COMMONWEALTH of VIRGINIA

February 26, 2016

MEMORANDUM

To: All Holders of the Virginia Department of Transportation's 2008 Road and Bridge Standards

VDOT	
ROAD AND BRIDGE STANDARDS	
REVISION DATE	SHEET 1 OF 1
02/16	1301.10

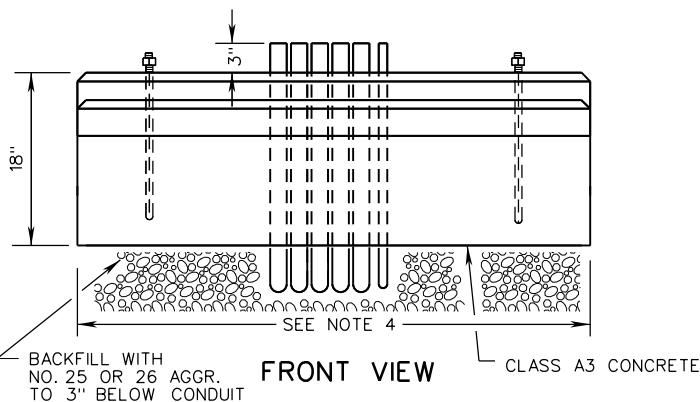
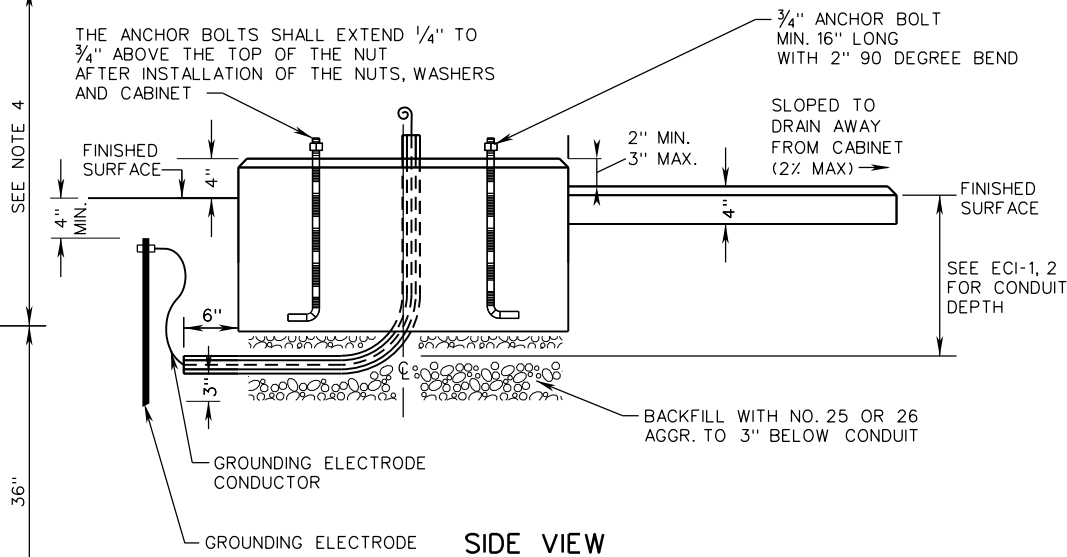
<u>PAGE</u>	<u>INTERIM</u>	<u>STANDARD</u>	<u>REVISION</u>
1301.10	IIS013_12	CF-1	REVISED AGGREGATE DEPTH, FOUNDATION DEPTH AND CONCRETE TYPE, CONDUIT REQUIREMENTS, ANCHOR BOLT REQUIREMENTS, CONCRETE PAD NOTES. REVISED NOTES.
1301.20	IIS13_13	CF-2	REVISED AGGREGATE DEPTH, FOUNDATION DEPTH AND CONCRETE TYPE, CONDUIT REQUIREMENTS, ANCHOR BOLT REQUIREMENTS, CONCRETE PAD NOTES. REVISED NOTES.
1301.30	IIS13_14	CF-3	REVISED AGGREGATE DEPTH, FOUNDATION CONCRETE TYPE, CONDUIT REQUIREMENTS, AND CONCRETE PAD NOTES. REVISED NOTES.
1301.31	IIS13_1301_31	CF-3	NEW SHEET TO SHOW THE COMMUNICATIONS SERVICE CONNECTION DETAIL.
1301.40	IIS13_1301_40	CF-4	NEW SHEET TO ADD THE CF-4 (CONTROLLER AND UPS CABINET FOUNDATION AND CONDUIT PLACEMENT DETAILS).
1302.24	IIS13_1302_24	MP-3	NEW SHEET REPLACING PREVIOUS MP-1 STANDARD. NEW REQUIREMENTS FOR LUMINAIRE ARM, MINIMUM AND MAXIMUM SIGNAL HEAD MOUNTING HEIGHTS, AND WIRING HOLE PLACEMENT. REVISED HANDHOLE REQUIREMENTS.

1302.26

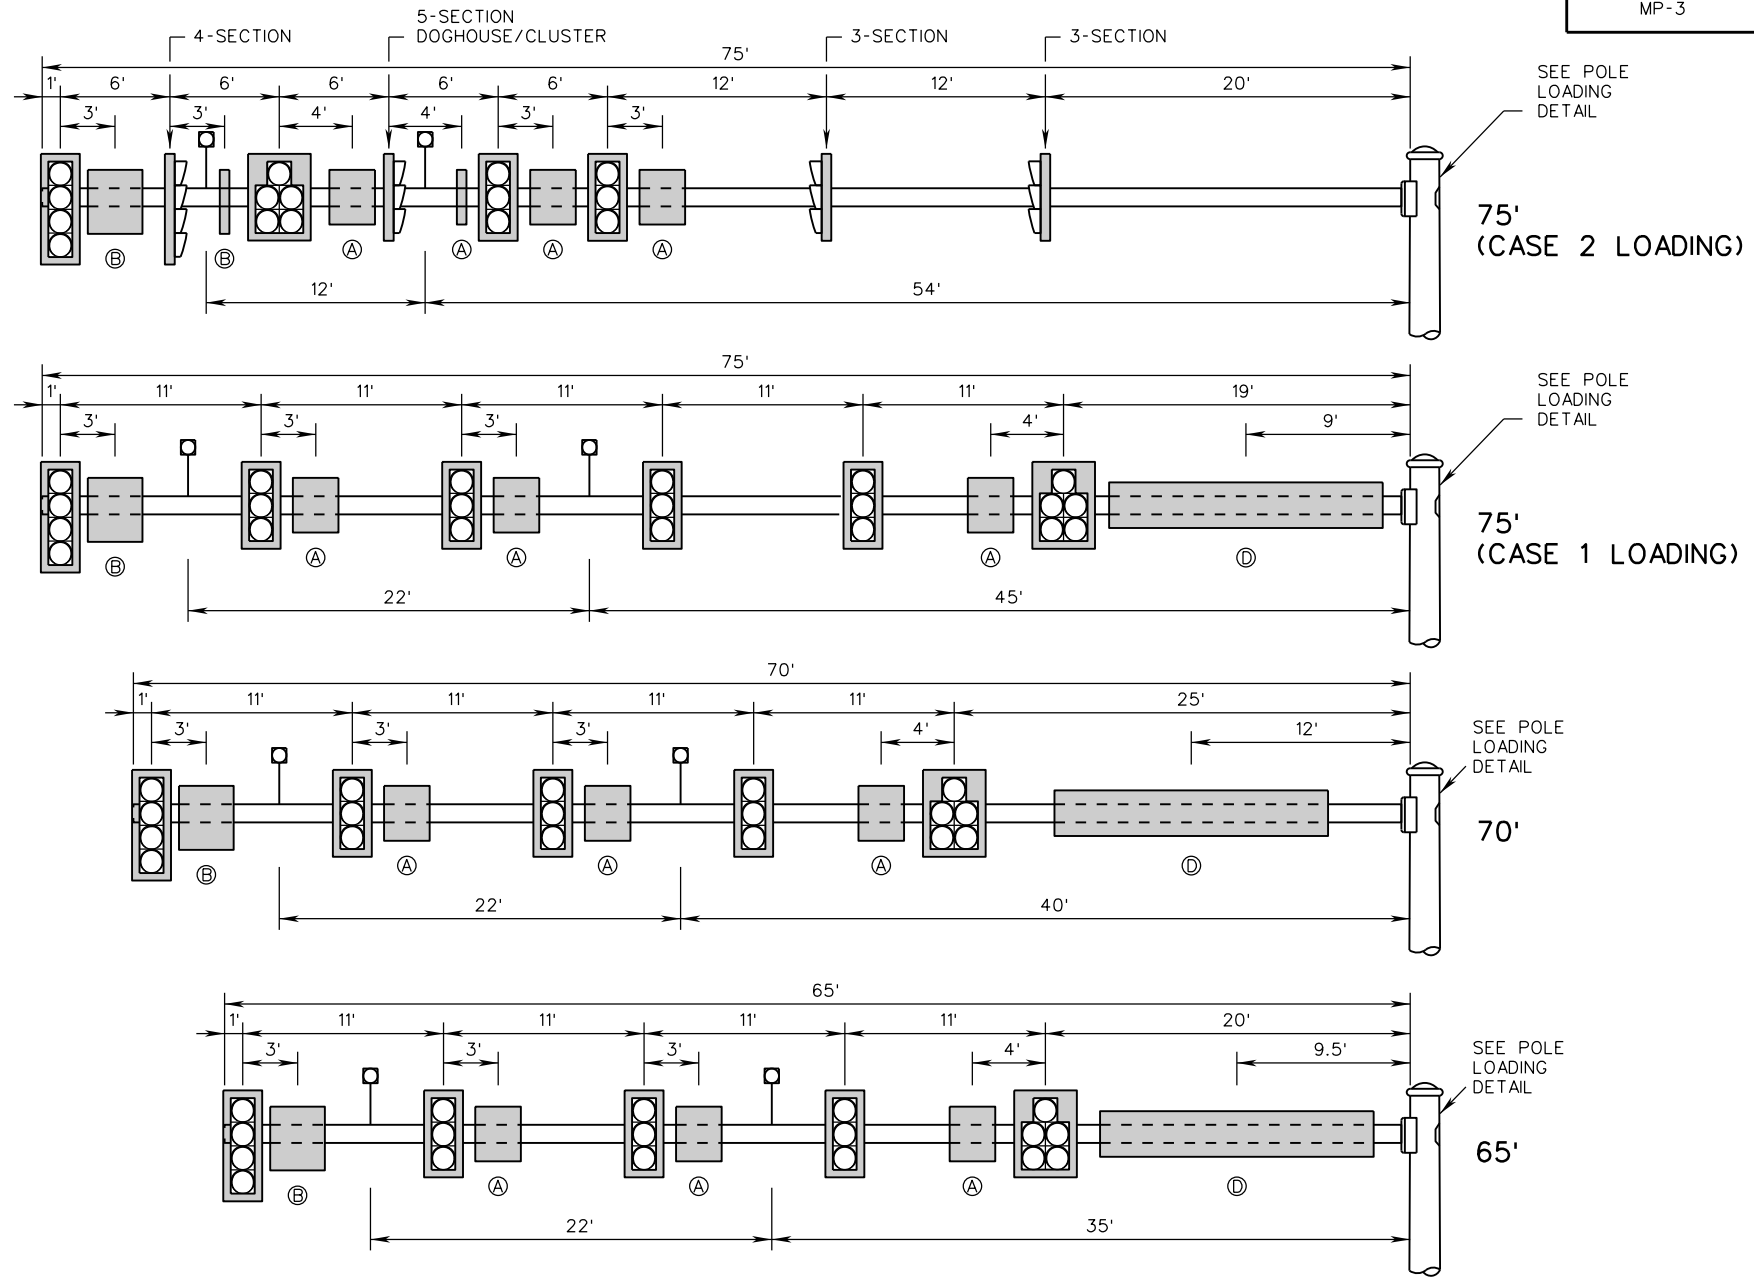
<u>PAGE</u>	<u>INTERIM</u>	<u>STANDARD</u>	<u>REVISION</u>
1302.26	IIS13_1302_26	MP-3	NEW SHEET SHOWING REQUIREMENTS FOR LOADS TO BE USED WHEN DESIGNING MAST ARM SIGNAL POLES.
1302.27	IIS13_1302_27	MP-3	NEW SHEET SHOWING REQUIREMENTS FOR LOADS TO BE USED WHEN DESIGNING MAST ARM SIGNAL POLES.
1303.10	IIS13_18	SW-1	REVISED NOTES AND DRAWING.
1303.20	IIS13_19	SW-2	REVISED NOTES AND DRAWING.
1303.40	IIS13_20	SMB-1	SMB-1, 2, AND 3 STANDARDS WERE SEPARATED INTO INDIVIDUAL SHEETS. REVISED NOTES AND DRAWINGS. ADDED MULTI-WAY MOUNTING ASSEMBLY.
1303.41	IIS13_1303_41	SMB-2	NEW SHEET FOR SMB-2. REVISED NOTES AND DRAWINGS. ADDED MULTI-WAY MOUNTING ASSEMBLY.
1303.42	IIS13_1303_42	SMB-3	NEW SHEET FOR SMB-3. REVISED NOTES AND DRAWINGS.
1304.10	IIS13_21	TA-1	ADDED NOTES AND REVISED DRAWING.
1306.10	IIS13_23	WD-1	REVISED NOTES AND DRAWING.
1306.20	IIS13_24	WD-2	REVISED NOTES AND DRAWING. CONTRACTOR IS REQUIRED TO DESIGN WOOD POLES.

1307.10

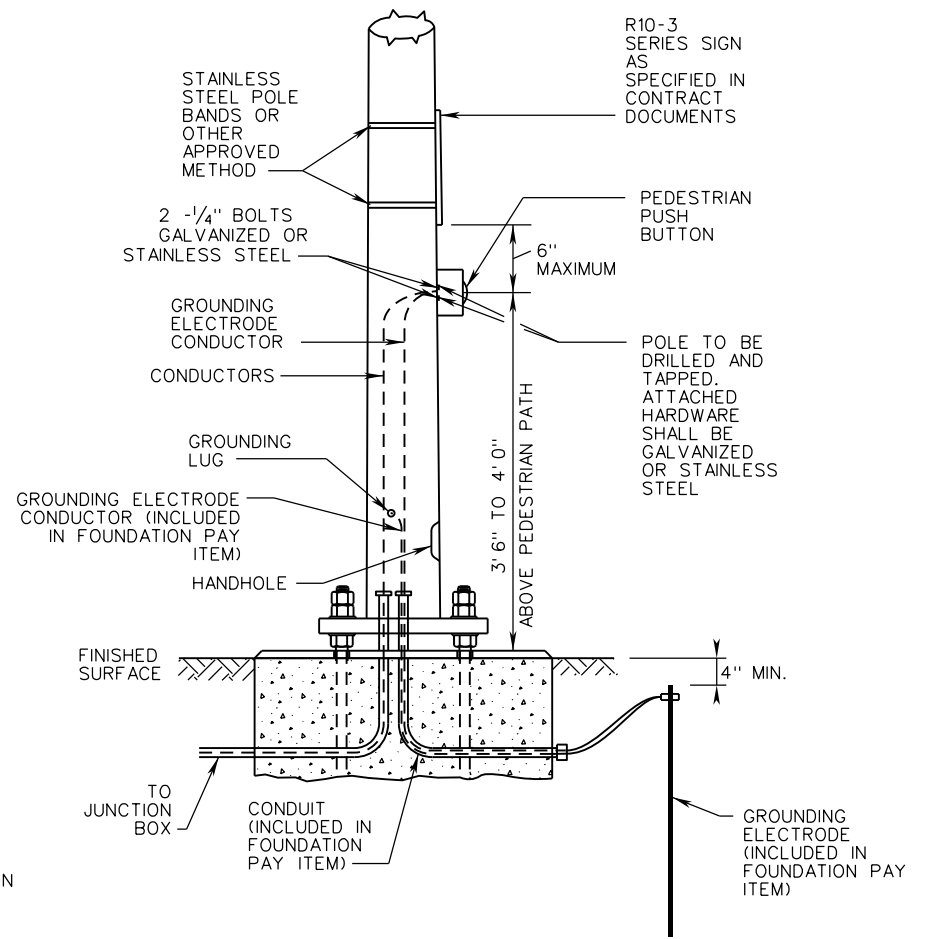
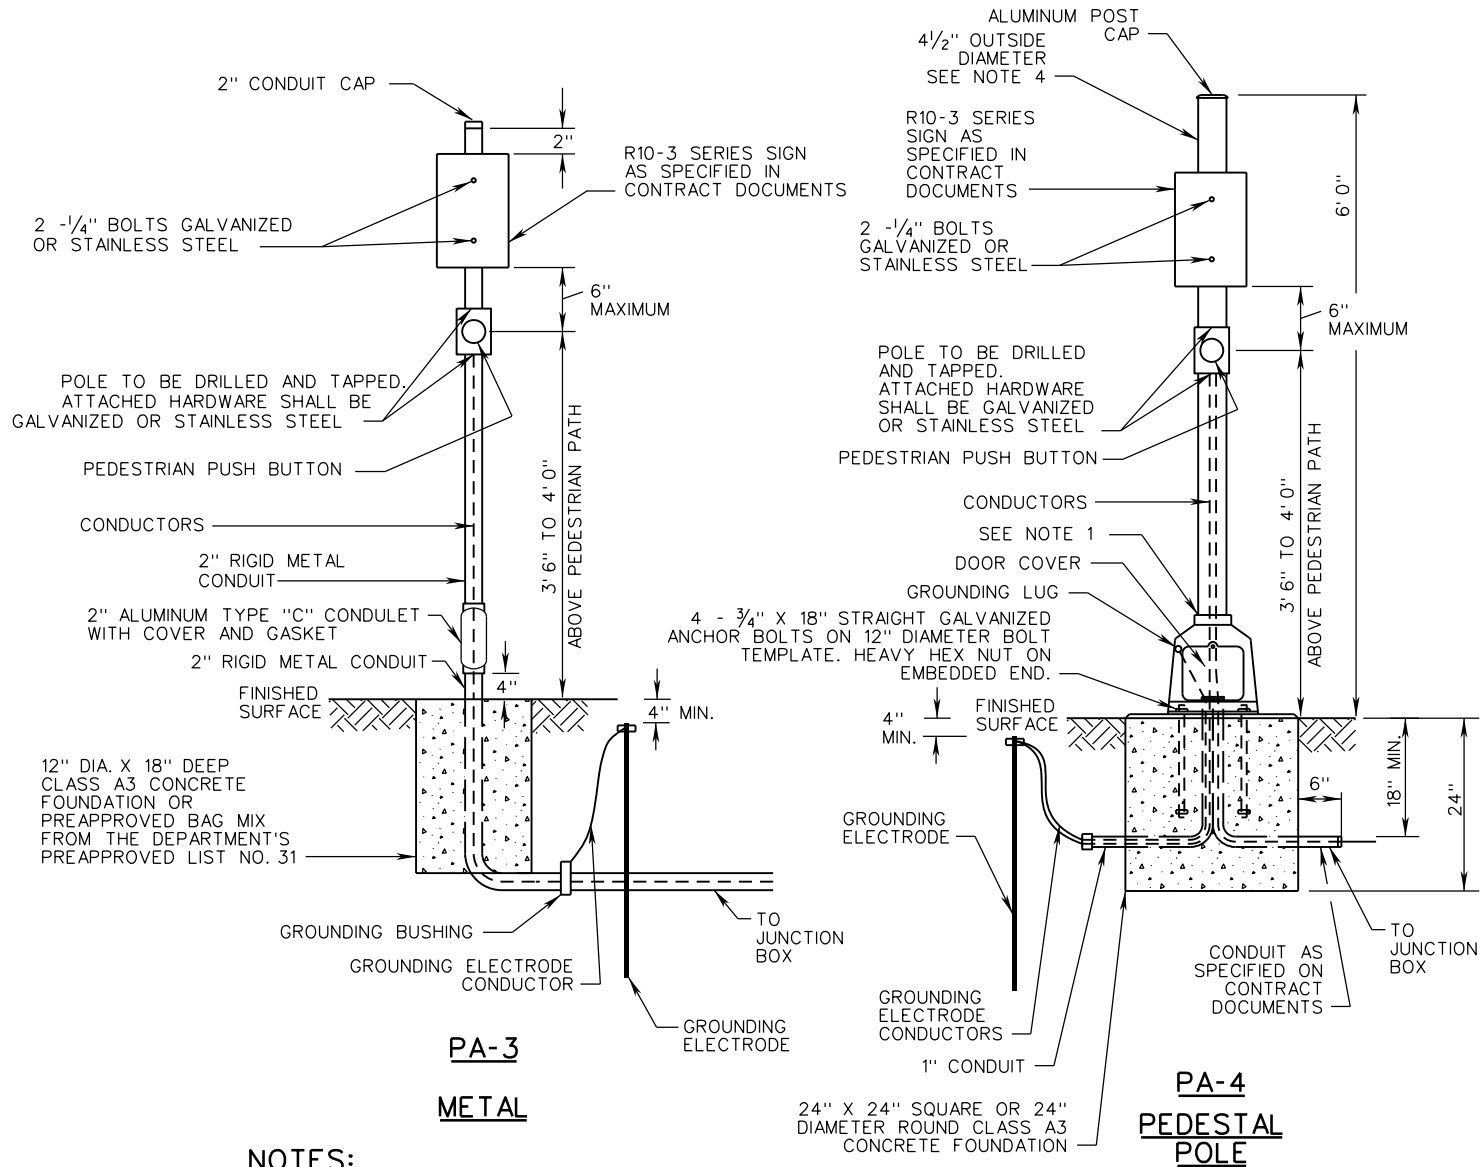
1307.10	IIS13_01	PA-1,2	REVISED NOTES AND DRAWING. PA-3 MOVED TO NEW SHEET.
1307.11	IIS13_1307_11	PA-3,4	NEW SHEET FOR PA-3. REVISED NOTES AND DRAWING. OPTION ADDED TO ALLOW FOR PREAPPROVED BAG MIX FOR CONCRETE FOUNDATION. ADDED PA-4 FOR PUSH BUTTON BREAKAWAY PEDESTAL POLE.

1308.10

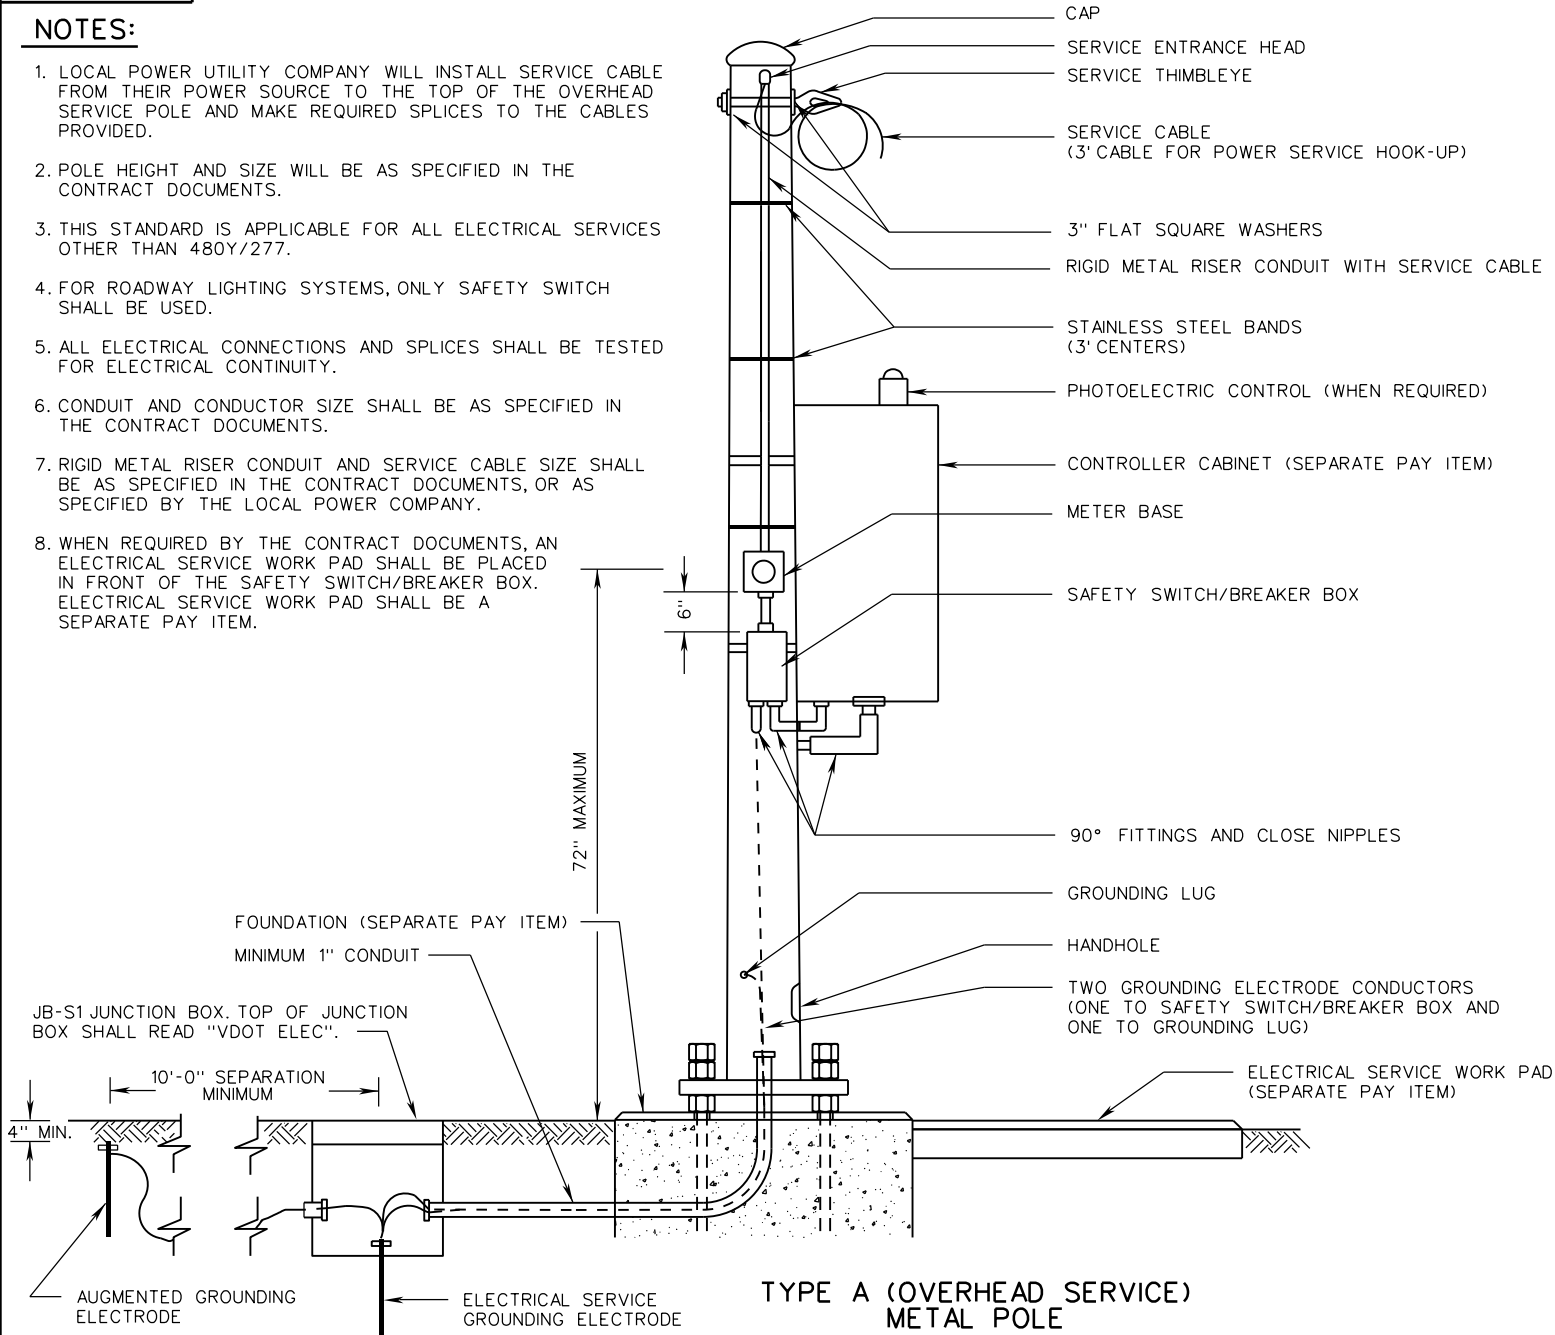
<u>PAGE</u>	<u>INTERIM</u>	<u>STANDARD</u>	<u>REVISION</u>
1308.10	IIS13_1308_10	SP-5,6,7,8,9	NOTE ADDED.
1312.10	IIS13_1312_10	SE-1	ALL NOTES REVISED. CLARIFIED SERVICE THIMBLEYE DRAWING. ADDED PHOTOELECTRIC CONTROL. ADDED HANDHOLE. SEVERAL LABELS CHANGED. "CONCRETE PAD" IS NOW "ELECTRICAL SERVICE WORK PAD" AND MEASUREMENTS HAVE BEEN REMOVED, BUT ARE REFLECTED IN THE SPEC BOOK. BASE OF THE POLE REVISED. GROUNDING ELECTRODES CHANGED IN DRAWING.
1312.11	IIS13_29	SE-1	ALL NOTES REVISED. SEVERAL LABELS CHANGED. BASE OF THE POLE REVISED. CONDUIT RUN UP THE POLE CHANGED FOR VISIBILITY. ADDED SEPARATE DETAIL FOR CONNECTION OF CONDUIT TO METER BASE. GROUNDING ELECTRODES CHANGED IN DRAWING.
1312.20	IIS13_1312_20	SE-2	ALL NOTES REVISED. CLARIFIED SERVICE THIMBLEYE DRAWING. ADDED PHOTOELECTRIC CONTROL. ADDED HANDHOLE. SEVERAL LABELS CHANGED. GROUNDING ELECTRODES CHANGED IN DRAWING.
1312.30	IIS13_1312_30	SE-3	ALL NOTES REVISED. CLARIFIED SERVICE THIMBLEYE DRAWING. BASE OF THE POLE REVISED. ADDED HANDHOLE. GROUNDING ELECTRODES CHANGED IN DRAWING.

1312.31

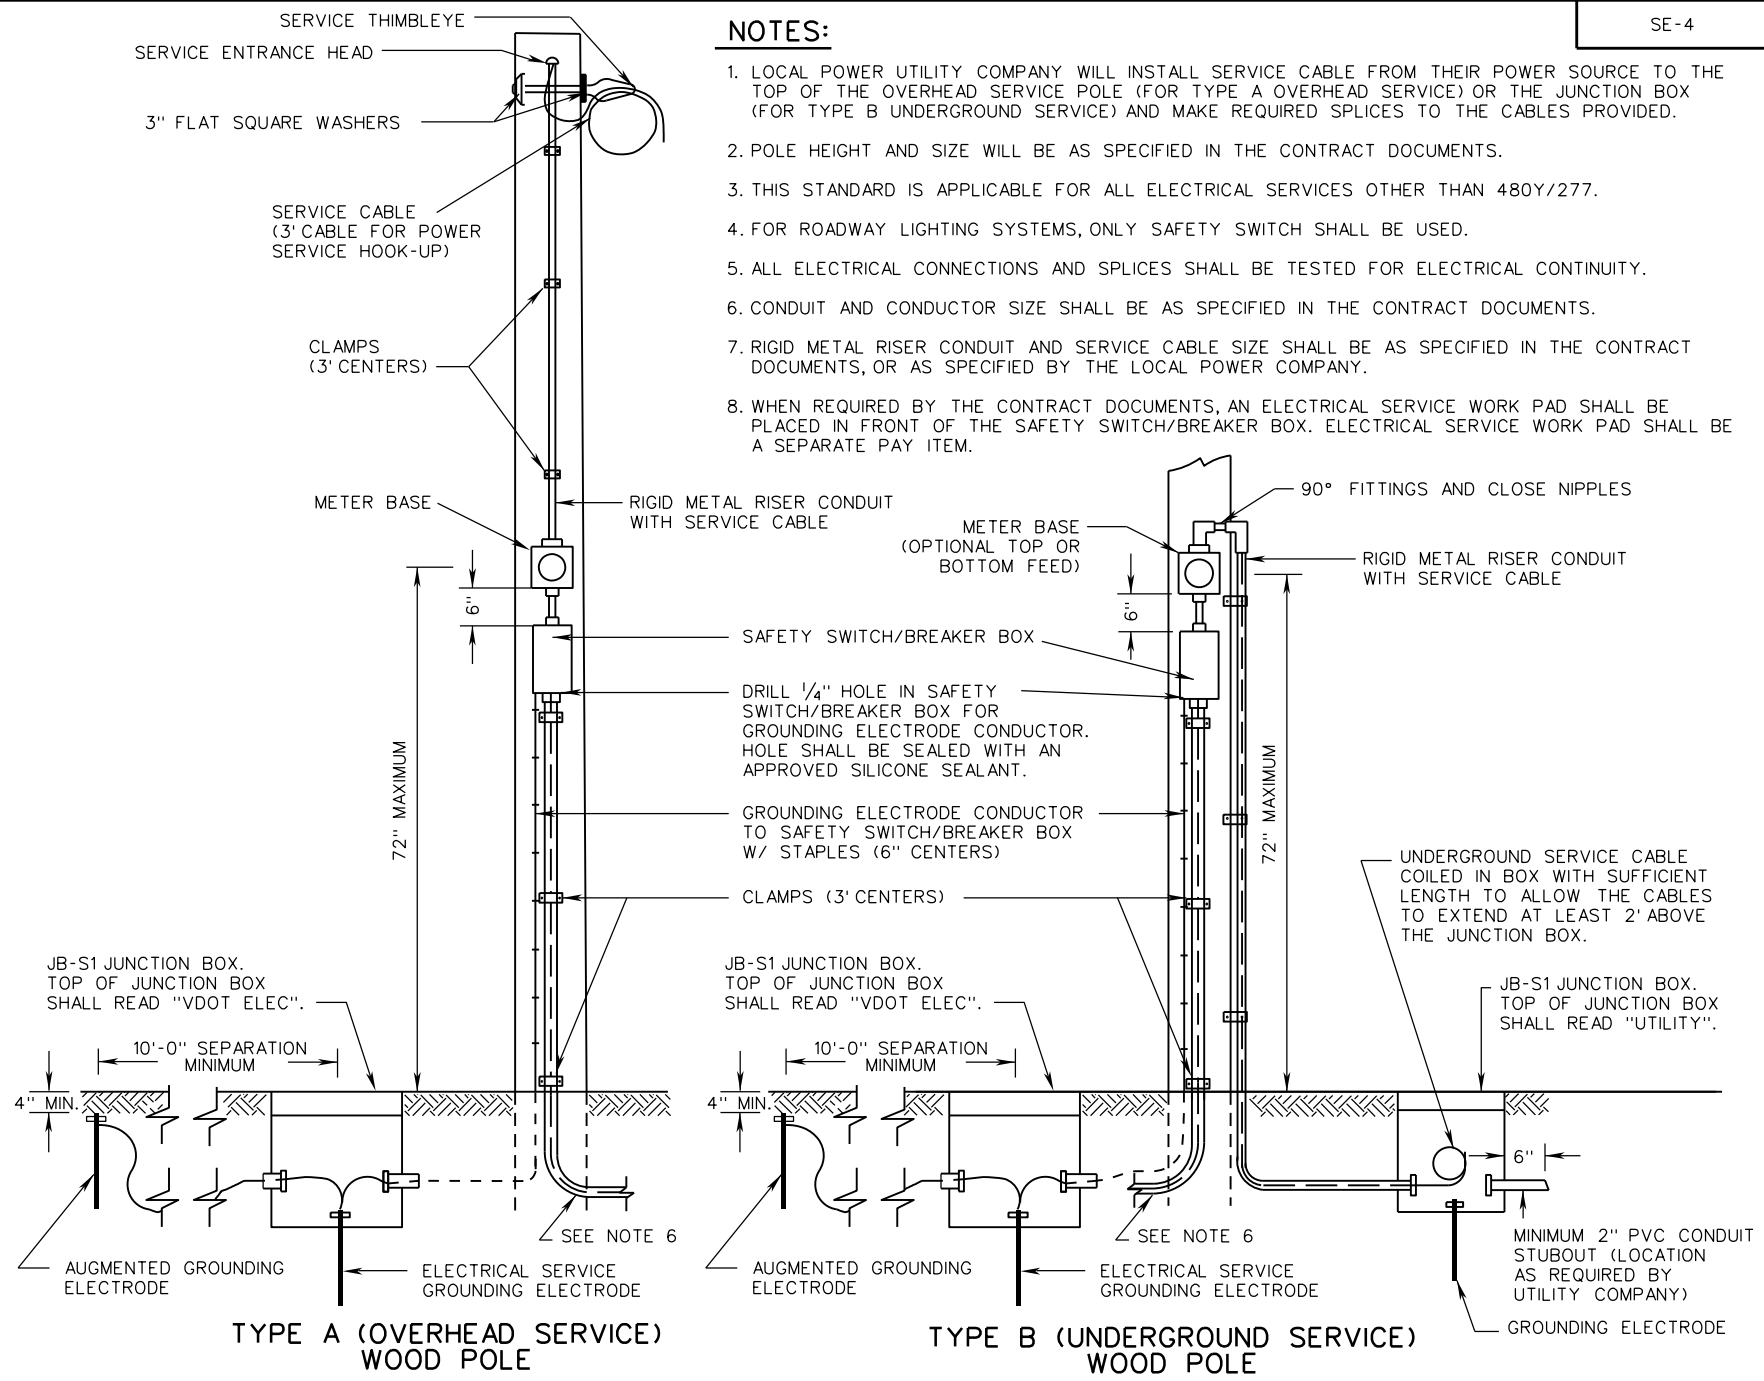
<u>PAGE</u>	<u>INTERIM</u>	<u>STANDARD</u>	<u>REVISION</u>
1312.31	IIS13_1312_31	SE-3	ALL NOTES REVISED. SEVERAL LABELS CHANGED. BASE OF THE POLE REVISED. CONDUIT RUN UP THE POLE CHANGED FOR VISIBILITY. ADDED SEPARATE DETAIL FOR CONNECTION OF CONDUIT TO METER BASE. GROUNDING ELECTRODES CHANGED IN DRAWING.
1312.40	IIS13_1312_40	SE-4	ALL NOTES REVISED. CLARIFIED SERVICE THIMBLEYE DRAWING. SEVERAL LABELS CHANGED. GROUNDING ELECTRODES CHANGED IN DRAWING.
1312.50	IIS13_30	SE-5	ALL NOTES REVISED. SEVERAL LABELS CHANGED. BASE OF THE POLE REVISED. CONDUIT RUN UP THE POLE CHANGED TO MEET NEC CODE. GROUNDING ELECTRODES CHANGED IN DRAWING.
1312.60	IIS13_31	SE-6	ALL NOTES REVISED. SEVERAL LABELS CHANGED. BASE OF THE POLE REVISED. CLARIFIED CONDUIT RUN. GROUNDING ELECTRODES CHANGED IN DRAWING.
1312.70	IIS13_32	SE-7	NEW DRAWING (SE-4 & SE-7 WERE IDENTICAL). ALL NOTES REVISED. SEVERAL LABELS CHANGED. GROUNDING ELECTRODES CHANGED IN DRAWING.
